September 19, 2025

## **ADDENDUM NO. 1**

### **DNR-250004 GREAT COUNCIL OBSERVATION TOWER**

1587 US-68,  
Xenia, OH 45385

1 Ground Floor - Code Plan  
3/16" = 1'-0"

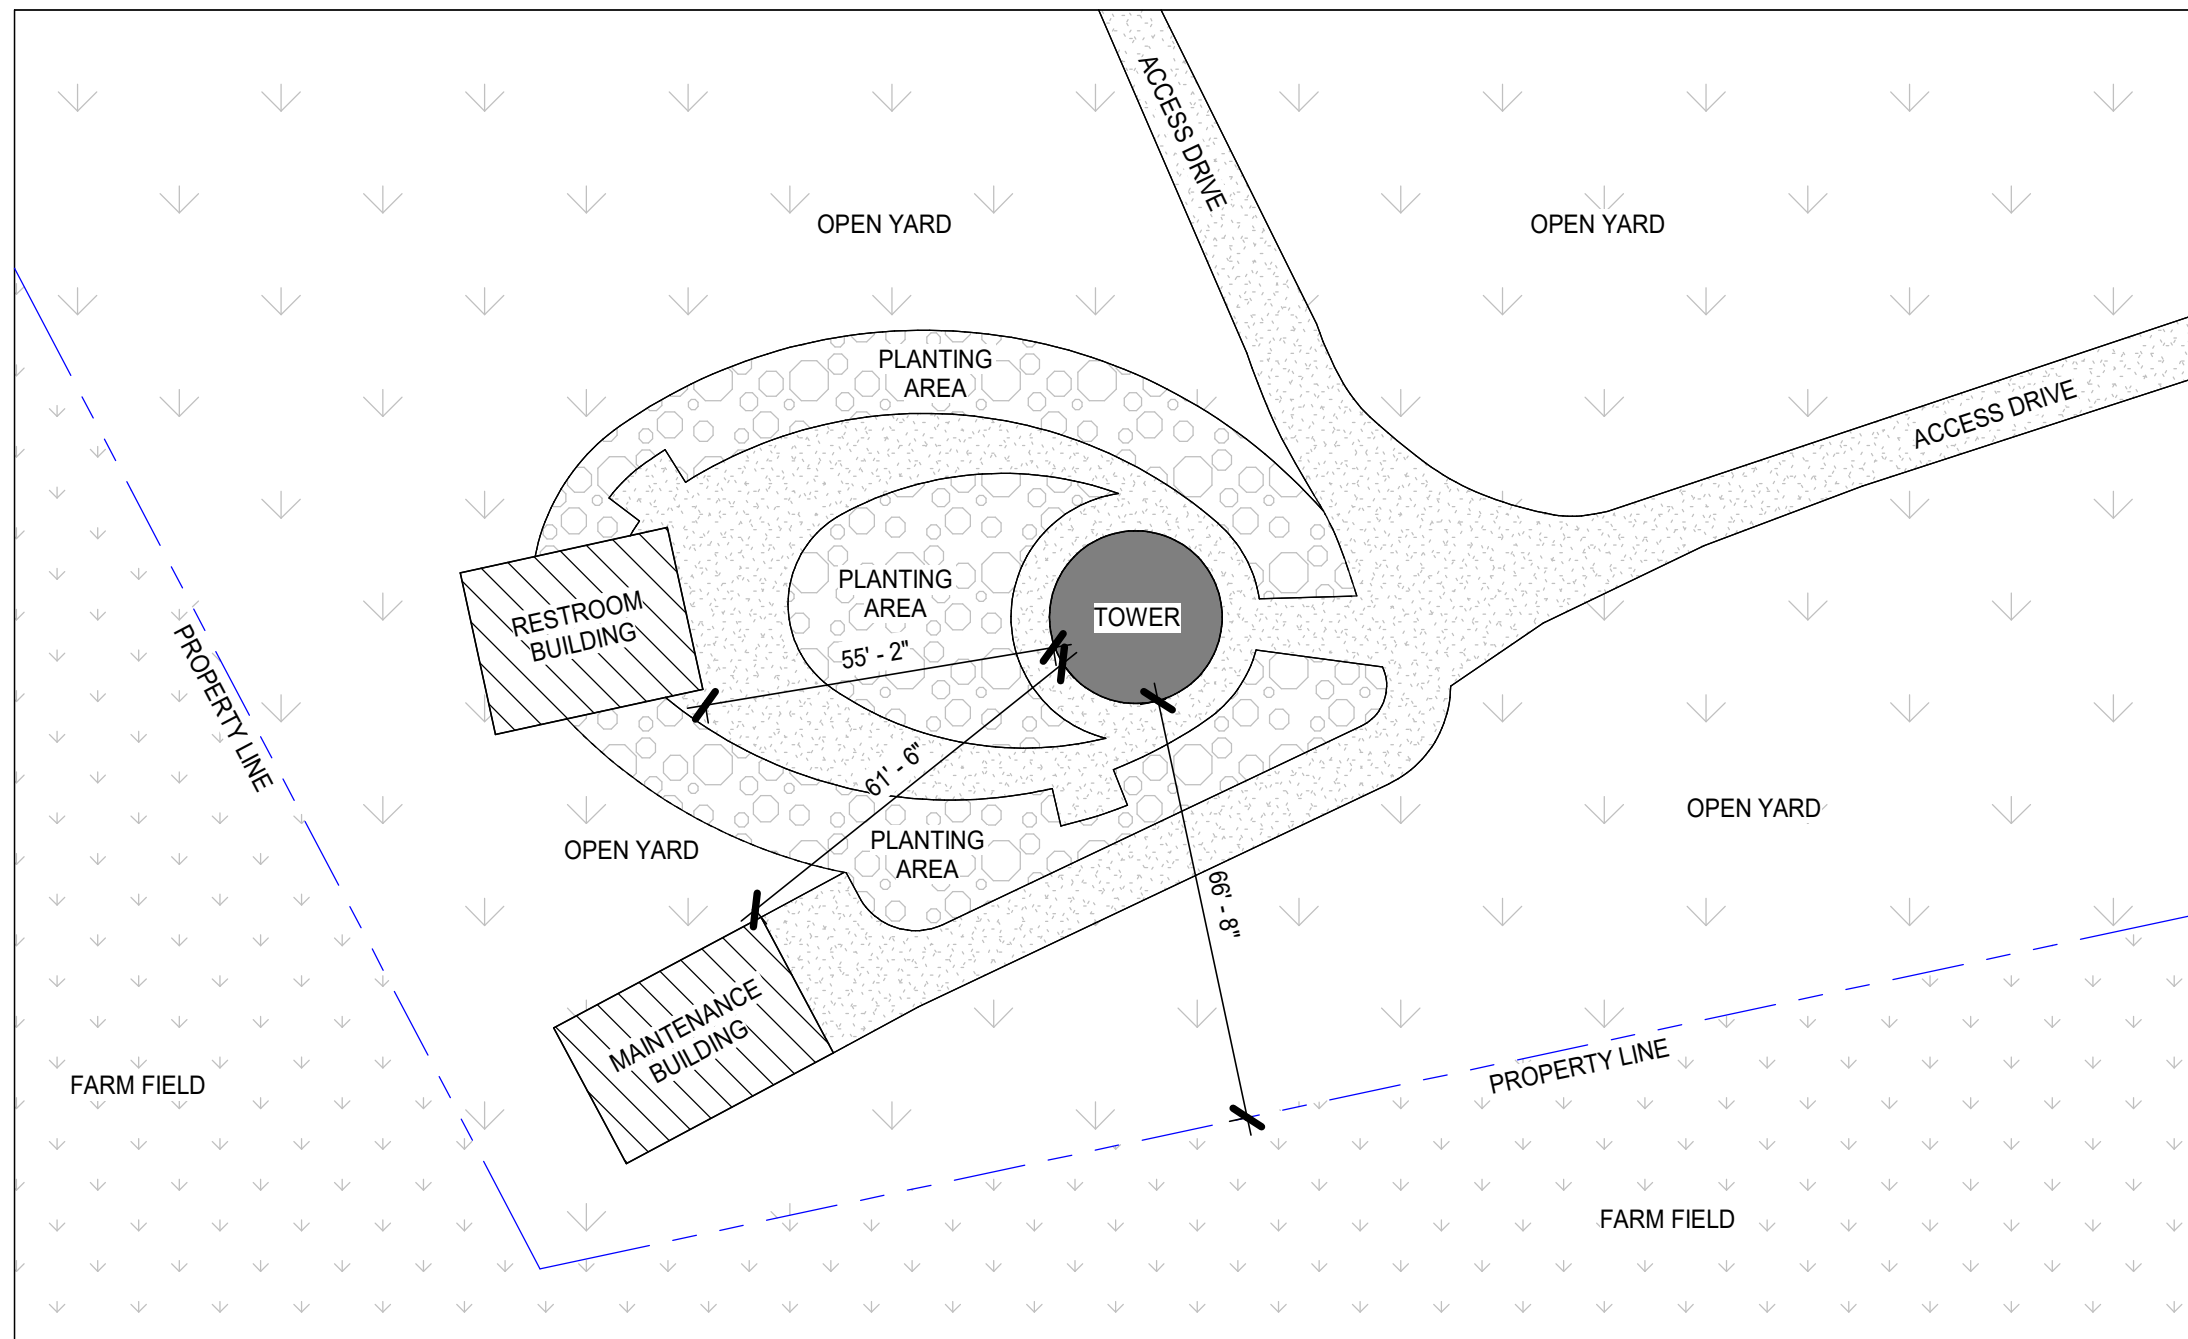
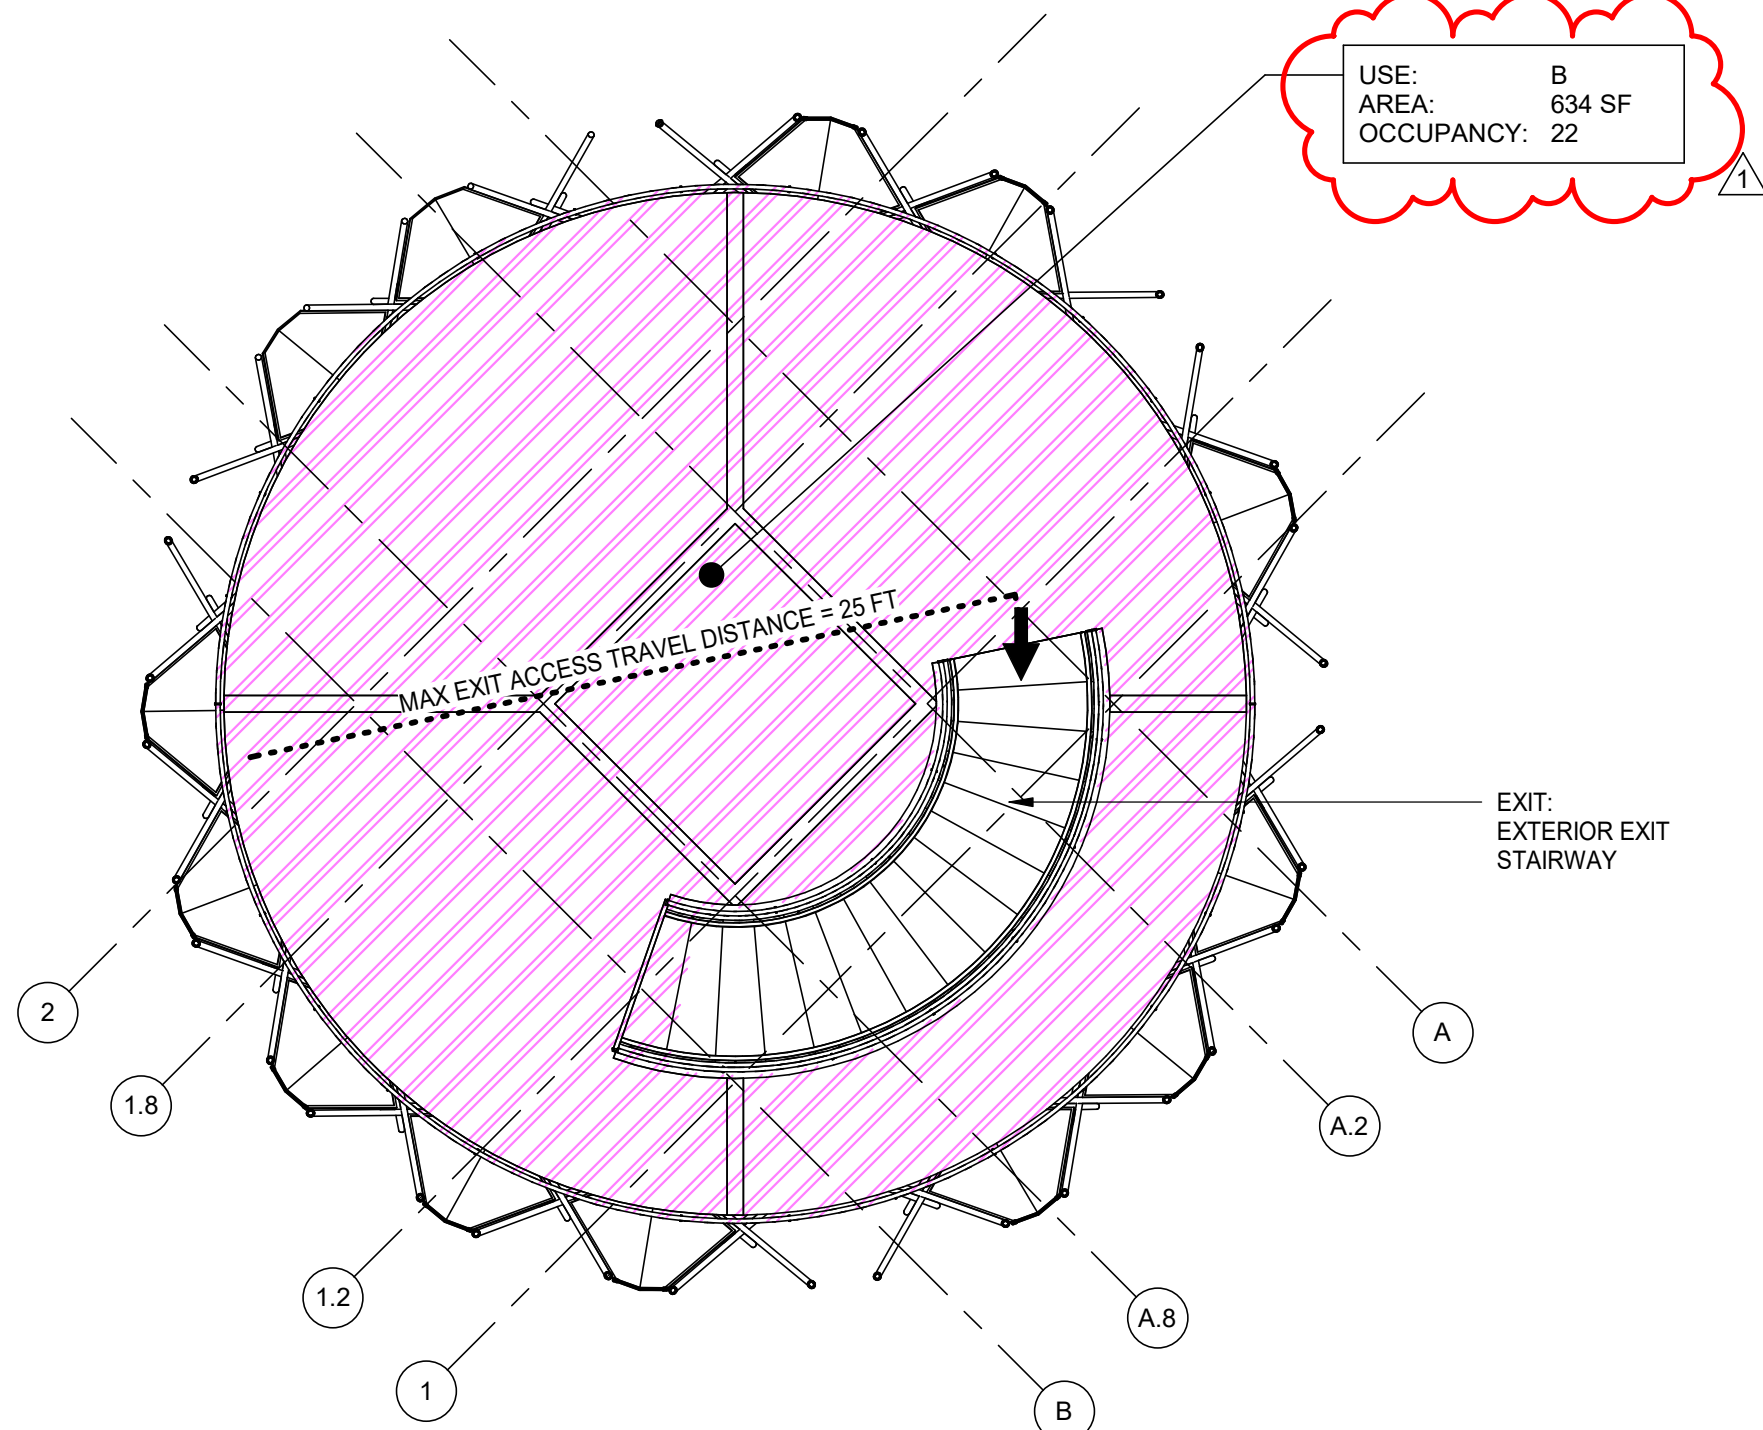
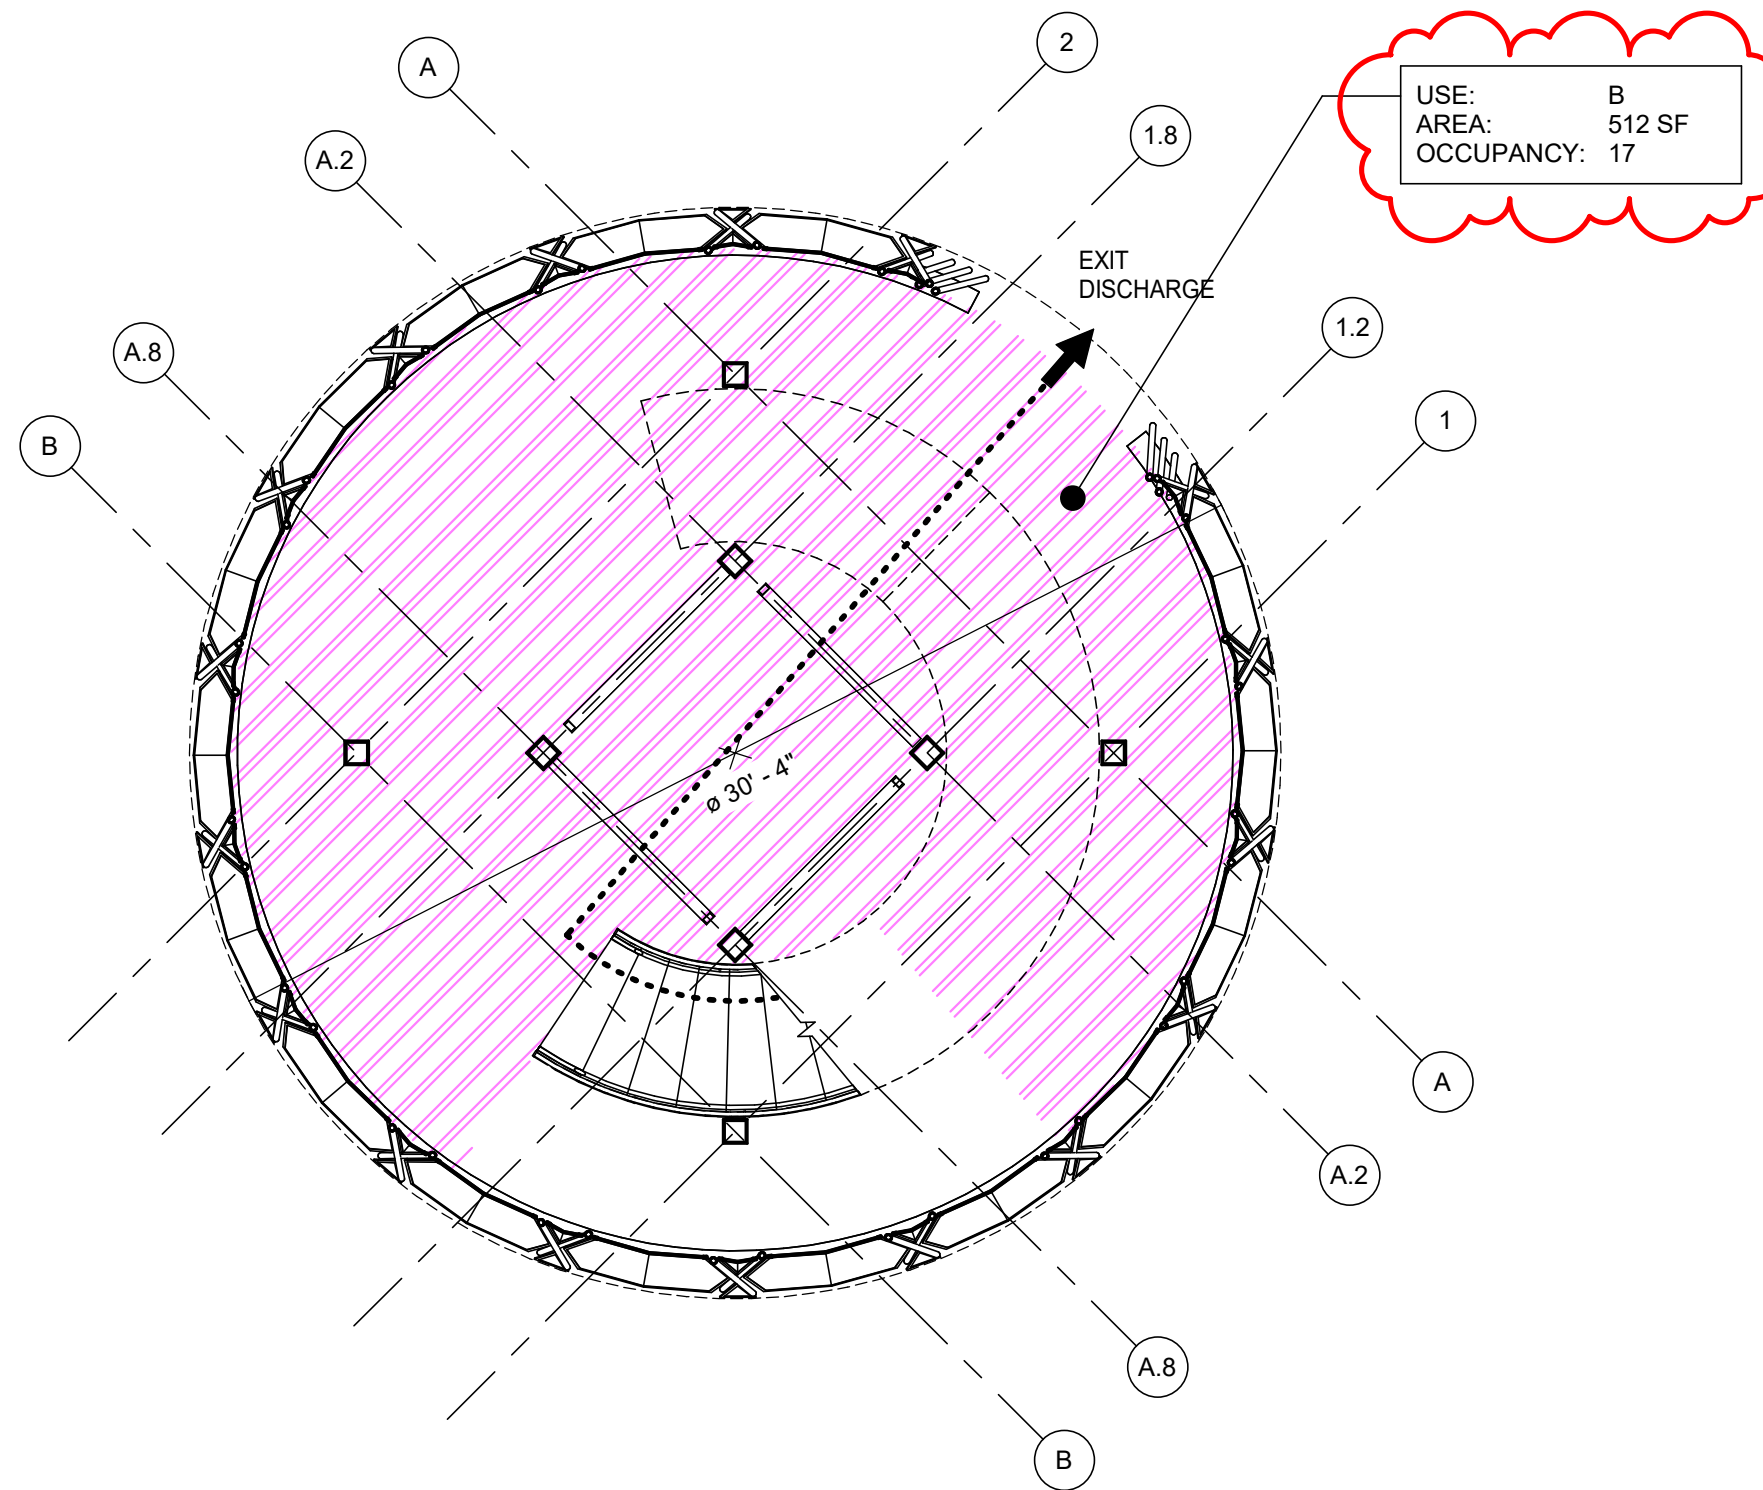
### **ITEM 5 T-G2 – CODE ANALYSIS - TOWER**

Revised occupancy to B use.

Removed Floor Occupancy Schedule.
